**SUPPLEMENTAL DATA
TO THE
OPERATION & MAINTENANCE MANUAL
RADSTAR SYSTEM
MODELS PD-4, PDE-4 AND PDX-4
FOR THE PDE-5 and PDX-5**

Date: Feb 1 2006
Dwg: 201313S

PDE-5 and PDX-5

Noise Suppression Components

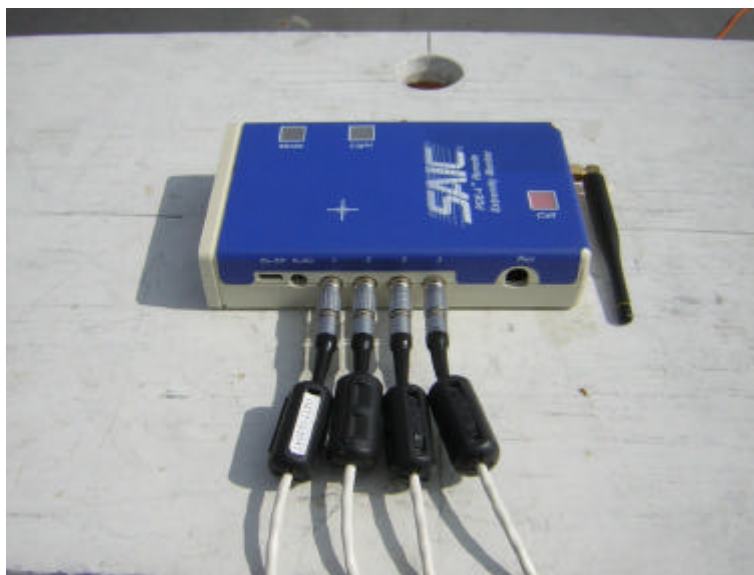
The upgraded PDE-5 has been re-certified to be compliant with Part 15 of the FCC rules. Certification testing indicated that electrical noise suppression components are required on each probe cable. The noise suppression components must be installed on all external probe cables as shown in the following figure and must remain in place at all times.
